**MICROCHIP****PIC18F2423/2523/4423/4523****PIC18F2423/2523/4423/4523 Rev. B4 Silicon Errata**

The PIC18F2423/2523/4423/4523 Rev. B4 parts you have received conform functionally to the Device Data Sheet (DS39755B), except for the anomalies described below. Any Data Sheet Clarification issues related to the PIC18F2423/2523/4423/4523 will be reported in a separate Data Sheet errata. Please check the Microchip web site for any existing issues.

The following silicon errata apply only to PIC18F2423/2523/4423/4523 devices with these Device/Revision IDs:

FIGURE 1: SCK PULSE VARIATION USING TIMER2/2**Work around**

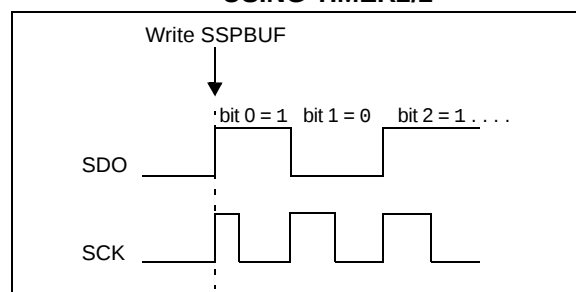
When the SPI is using Timer2/2 as the clock source, a shorter than expected SCK pulse may occur on the first bit of the transmitted/received data (Figure 1).

To avoid producing the short pulse, turn off Timer2 and clear the TMR2 register, load the SSPBUF with the data to transmit and then turn Timer2 back on. Refer to Example 1 for sample code.
